Joseph M. Farley Nuclear Plant  
Clarification Of Request For Technical Specification Changes  
Elimination of Containment Spray Additive System

Enclosure: Proposed Drawing Of Cutting And Capping In Class 2 Piping

**PROPOSED DRAWING OF CUTTING AND CAPPING IN CLASS 2 PIPING**

Attachment 3: Proposal "B" Containment Spray P&amp;ID (DCP 95-1-8931)

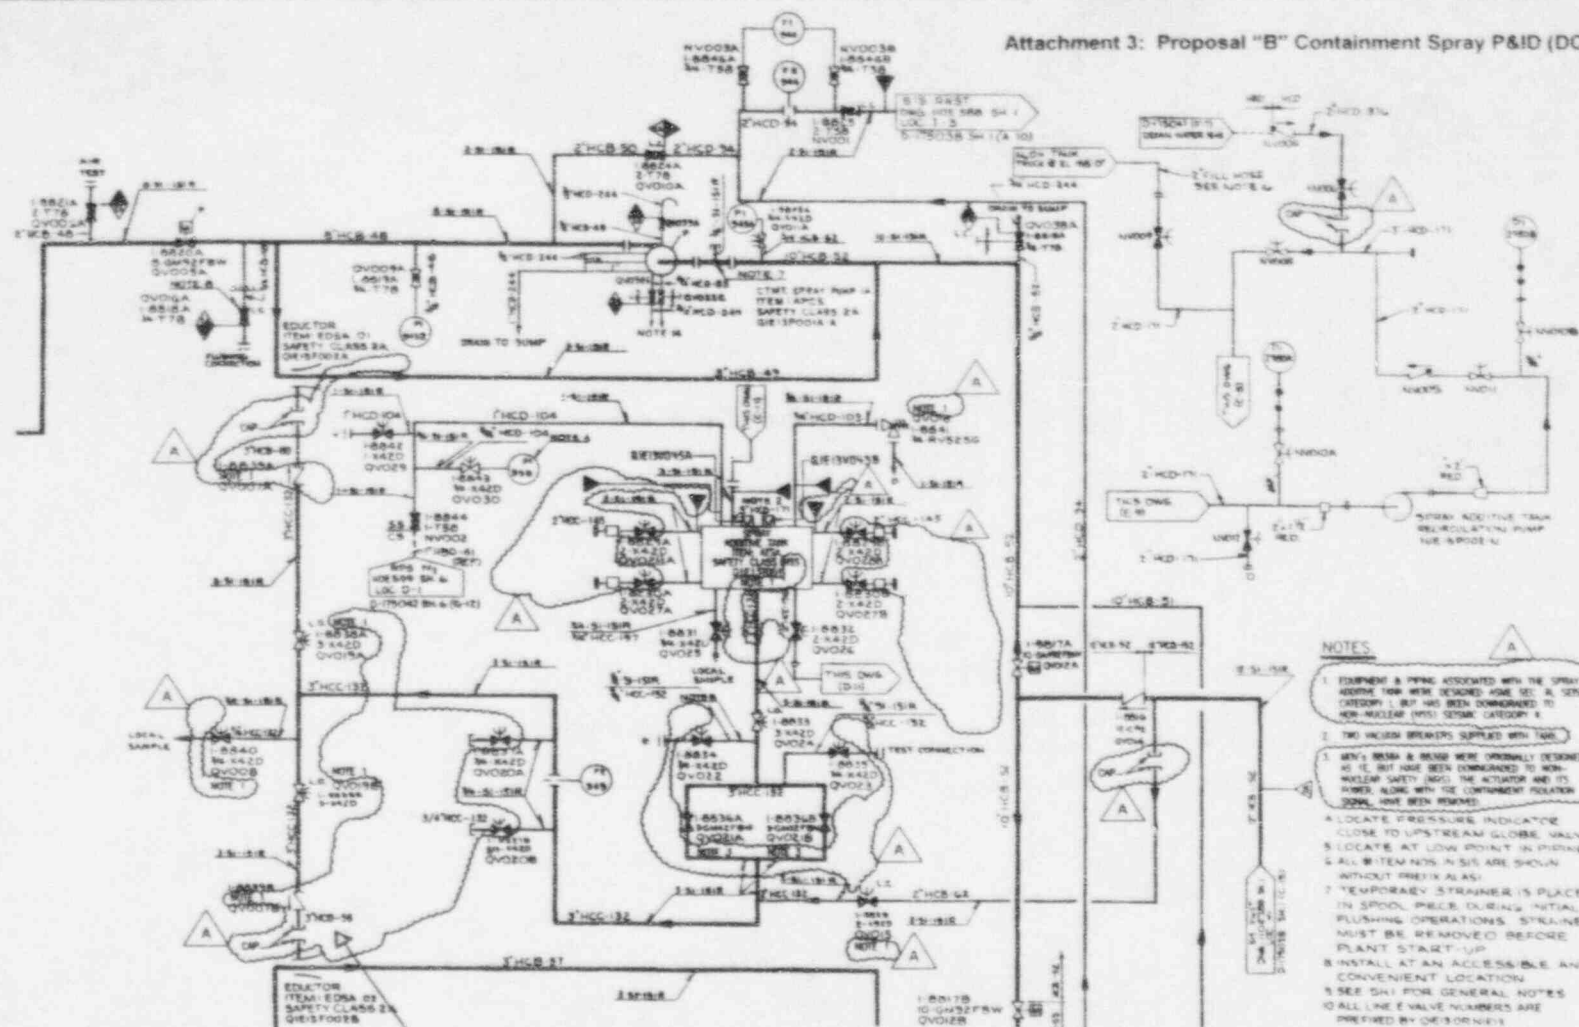
The paragraph should have stated that the blind flanges and containment spray system piping will meet ASME Section III Class 2 requirements vice meeting ASME Section III Class 3 requirements. The fact that the blind flanges at FNP are being installed in ASME Section Class 2 containment spray piping and not Class 3 piping was not recognized in the preparation of the FNP NRC submittal. The Enclosure provides a drawing that shows the location of the blind flanges being installed.
